# UNITED STATES PATENT AND TRADEMARK OFFICE

APPLICATION NO.	FILING DATE	FIRST NAMED INVENTOR	ATTORNEY DOCKET NO.	CONFIRMATION NO.
09/455,991	12/06/1999	HISASHI OHTANI	07977/213002	5835

# Office Action Summary

## **DETAILED ACTION**

**FIG. 8**  
**(Prior Art)**

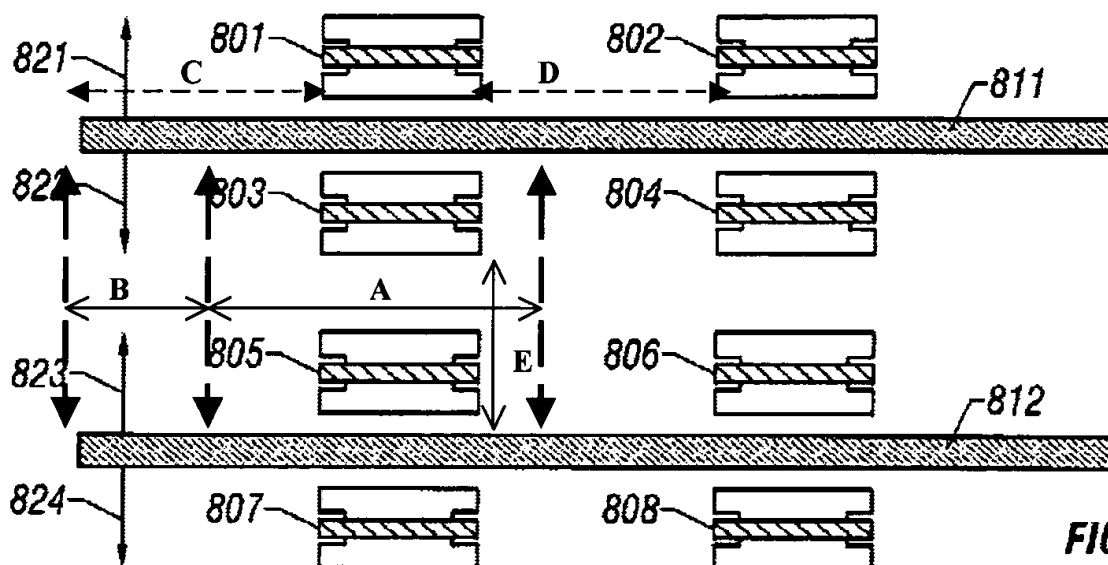
Regarding claims 6, 9, 23, 31, 39, 55, and 63, Applicant acknowledges a well-known method comprising the steps of: forming an amorphous semiconductor film (see page 1, lines 24-26) on an substrate (see page 1, lines 11-13); providing a metal element (811, 812) capable of promoting crystallization of the amorphous semiconductor film to form a first metal element added region (811) and a second metal element added region (812) (see fig. 8, below); crystallizing the amorphous semiconductor film so that a crystal growth (822, 823) proceeds in a crystal growth direction parallel to the insulating surface to form first and second crystalline portion (see regions A and B between the metal element 811 and 812 in Fig. 8, below); patterning the crystalline semiconductor film to form at least one crystalline island or active region (803) using only the first crystalline portion (see region A between the metal element 811 and 812 in Fig. 8, below); wherein the first metal element added region (811) is away from the second metal element added region (812); wherein carrier move in the crystalline semiconductor island (803) in a carrier moving direction identical

with the crystal growth direction (822, 823) (see page 4, lines 9-11 and fig. 8, below); wherein the second metal element added region (812) is located apart from the crystalline semiconductor island (803) by a distance (E) (see Fig. 8, below); wherein the first metal element added region (811) has a length extending longer from an end portion of the crystalline semiconductor island (803) in a longitudinal direction of the first metal element added region (consider the portion of the metal element (811) that is between the end side of the region (B) and the end side of the crystalline semiconductor island (803) in Fig. 8, below).

Regarding claims 7, 32 and 56, Applicant acknowledges that the lengths (C, D) of the first metal element added region (811) and the second element added region (812) are set to 50% or more of a crystal growth distance (please note that the regions C and D has a length which is about twice the length of 801 or 803 region, see Fig. 8, above).

Regarding claims 24, 40, 47-48, 64, and 71, applicant and Zhang et al., as stated before, teaches the claimed method (see rejection of claim 6, above). In addition, applicant acknowledges that the lengths (C, D) of the first metal element added region (811) and the second element added region (812) are set to 50% or more of a crystal growth distance (please note that the regions C and D has a length which is about twice the length of 801 or 803 region, see Fig. 8, above). With regards to the claimed length of 100  $\mu\text{m}$  or more, it would have been obvious to one of ordinary skill in the art, since it has been held that where the general conditions of a claim are disclosed in the prior art, discovering the optimum or working ranges involves only routine skill in the art. *In re Huang*, 40 USPQ2d 1685,1688(Fed. Cir. 1996) citing *In re Aller*, 105 USPQ 233., 235 (CCPA 1955).
